DAIMLER ARMoured CARTECHNICAL HANDBOOK - MODIFICATION INSTRUCTIONPreparation for fitting wireless set C12SUMMARY

1. To enable the Wireless set C12 to be fitted in place of the Wireless set No 19 the vehicle must first be modified in accordance with this instruction. The replacement of the wireless equipment is covered in Comms Inst J 617, Instr No 1.

Fig 1 - Fixing of ammunition carrier

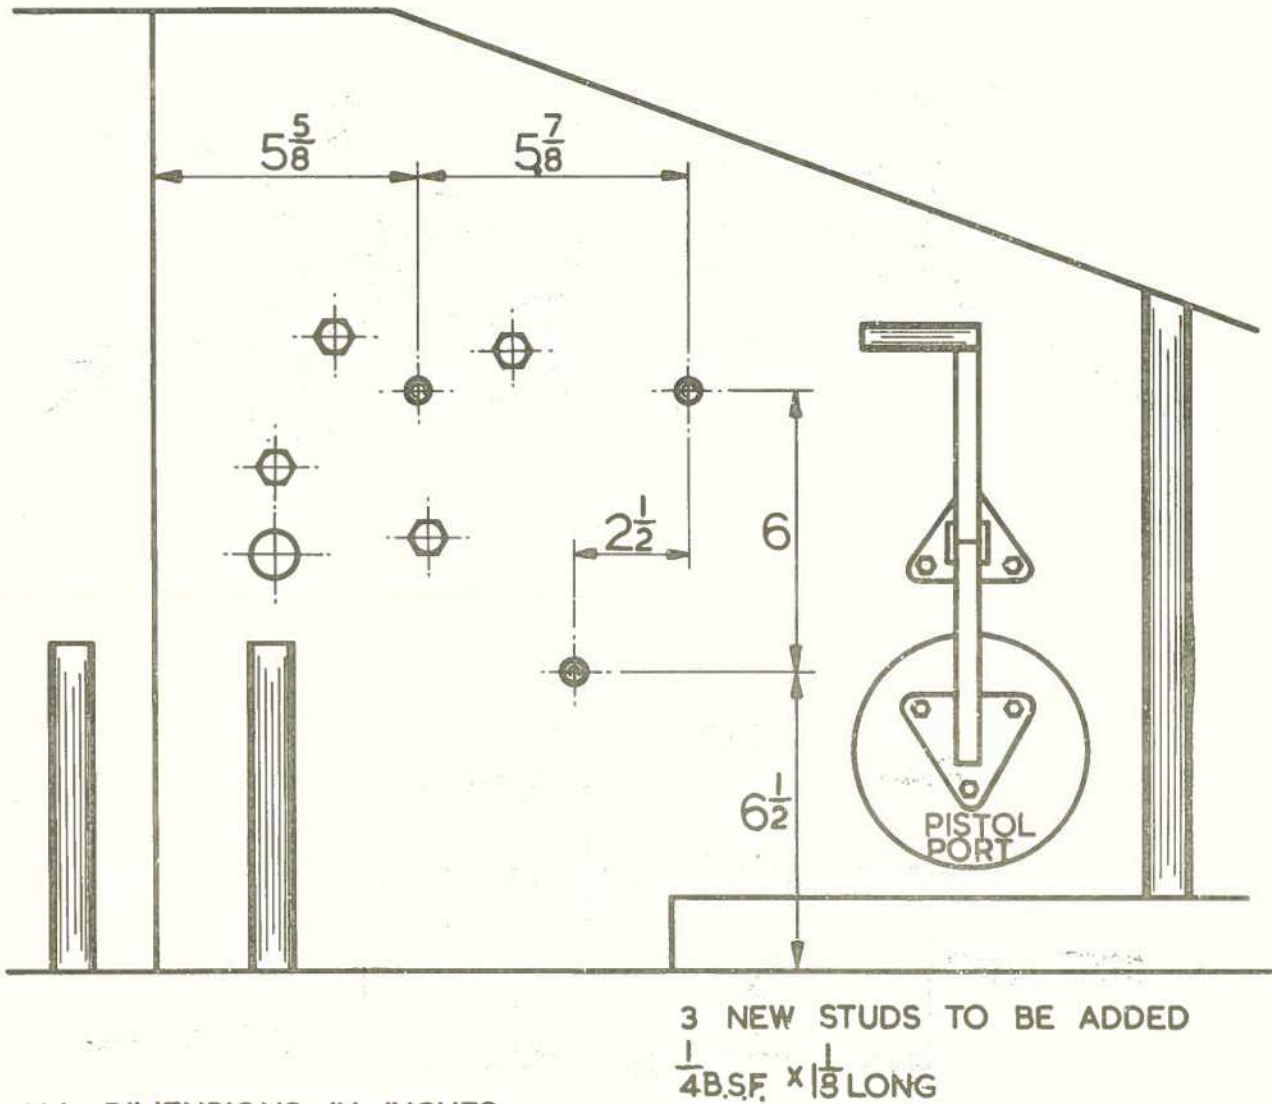
- (b) Remove and discard the securing bracket which is riveted to the carrier.
 - (c) Weld the right-hand support (FV 246571) and the left-hand support (FV 246572) to the carrier as shown in Fig 1.

- (d) Secure this assembly to the turret ring as shown in Fig 1, two replacement $\frac{3}{8}$ in. B.S.F. nuts and screws are provided should the original nuts and screws become damaged during removal.

Fig 2 - Position of studs turret r.h. wall

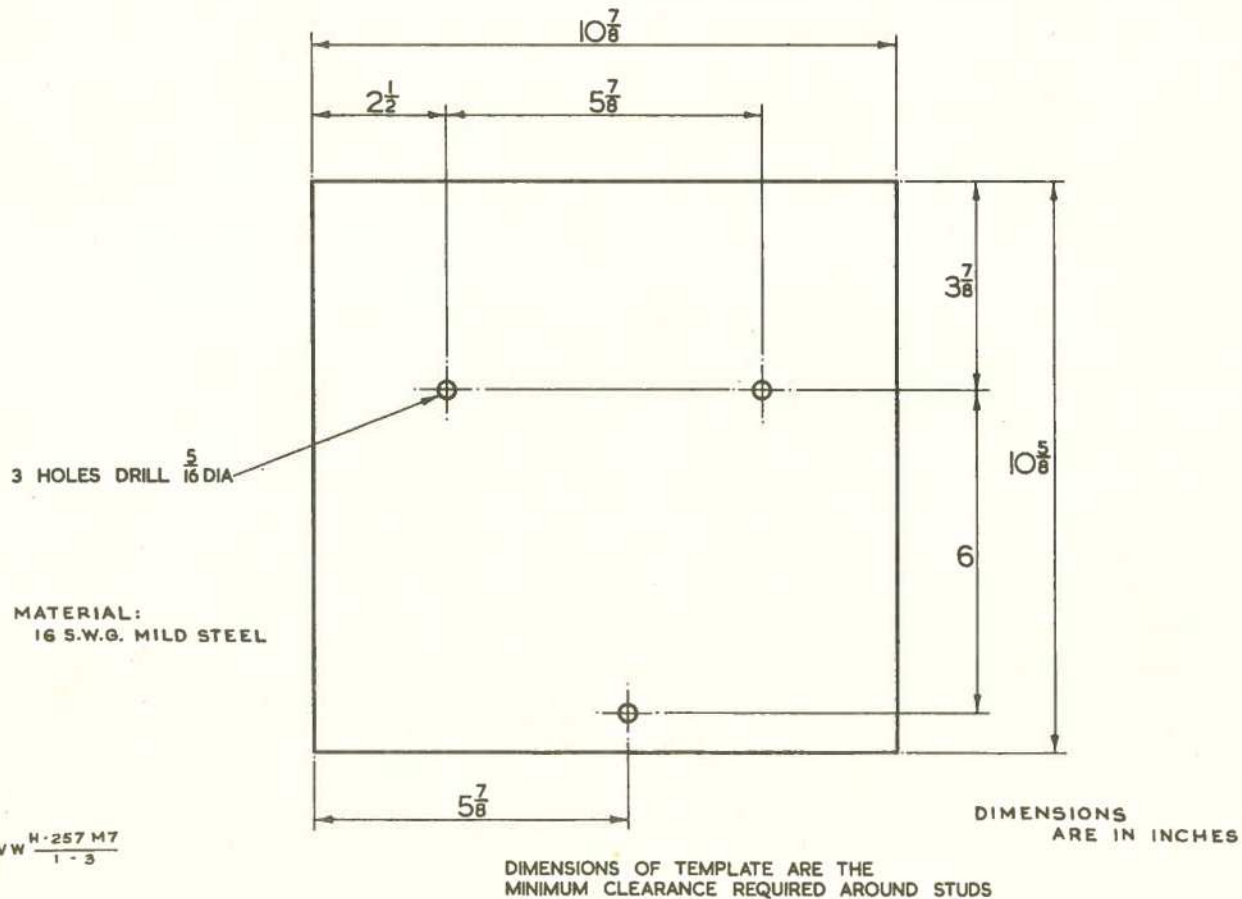
9. Weld three $\frac{1}{4}$ in. B.S.F. x $1\frac{1}{8}$ in. studs to the right-hand wall of the turret as shown in Fig 2. When marking out use the template in Fig 3 (to be made up locally) to ensure that the stud positions will give adequate clearance around the aerial tuning unit which will later be fitted on the studs. The template should be fitted over the studs when welded to check accuracy of positioning.

WARNING: When the electric stud welding equipment is being used, it is essential that the earth lead should be connected to the turret of the vehicle, to avoid damage to the turret race by passing heavy currents through it.
